SERVICE BULLETIN #126

Date: 7-25-90

This service bulletin applies to all Aerostar hot air balloons which are equipped with AFT 2-Point suspension cables.

Diagram One

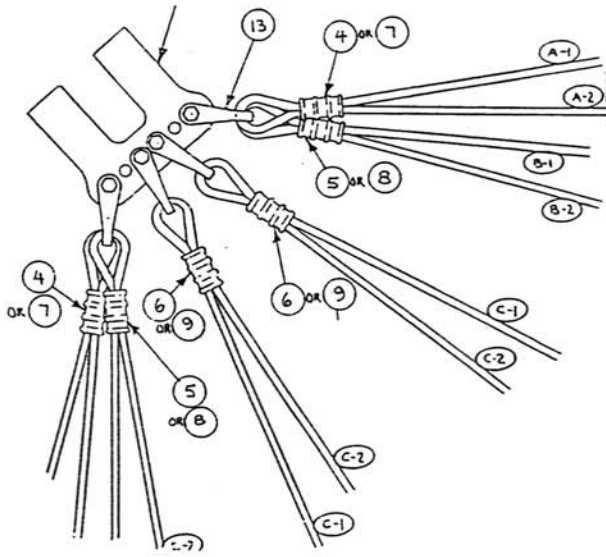
This service bulletin is issued to address service difficulties experienced with 2-Point AFT cable systems. All current 2-Point AFT systems utilize cable attachment to the suspension fitting as shown in Diagram 1. The difficulty with the fitting is that the cables may twist around the shackle and "pop" the cable thimble out of the cable loop, exposing the cable to the sharp edges of the shackle. This condition is addressed in Service Bulletin #124 and in part in #125.

This operation must be performed by a repair station, and must be performed on or before the next annual/100 hour inspection. The suspension block and shackle assemblies as shown in Diagram 1 must be replaced with assemblies as shown in Diagram 2 (a), (b), or (c), for 16 gore, 20 gore, or 24 gore balloons respectively.

Diagram Two (a), 16 gore

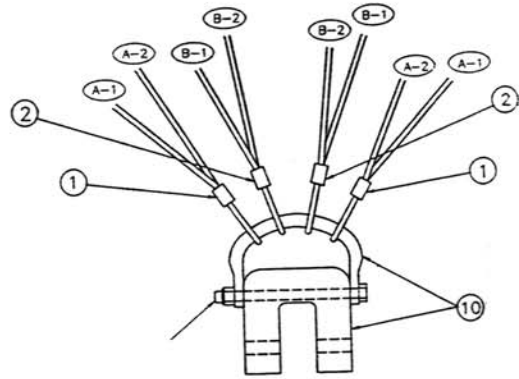
Each cable-pair assembly must be removed from its shackle and installed on the single shackle (in the order as shown on the respective diagram 2 (a), (b), or (c).) For locations of cable pair designators, (A-1, A-2, B-2, etc.) for respective cable sets, refer to Aerostar Instructions For Continued Airworthiness, Appendix J., Revision G. The grade-8 bolt is then installed through the shackle and suspension fitting as shown in the diagram, then torqued to 45-50 in-lbs. with alignment of the shackle with the suspension fitting as shown in diagram 3.

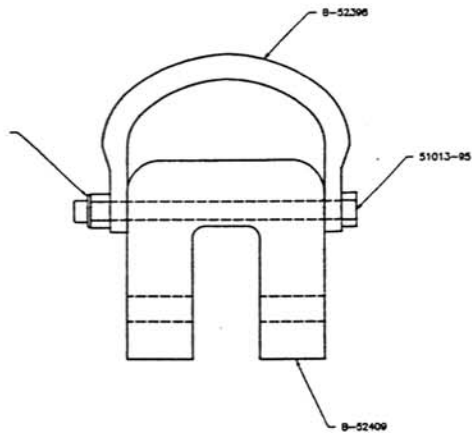
NOTE: 1. TORQUE NUT P/N 51013-12 TO 50 IN LBS. AFTER CABLES ARE INSTALLED.
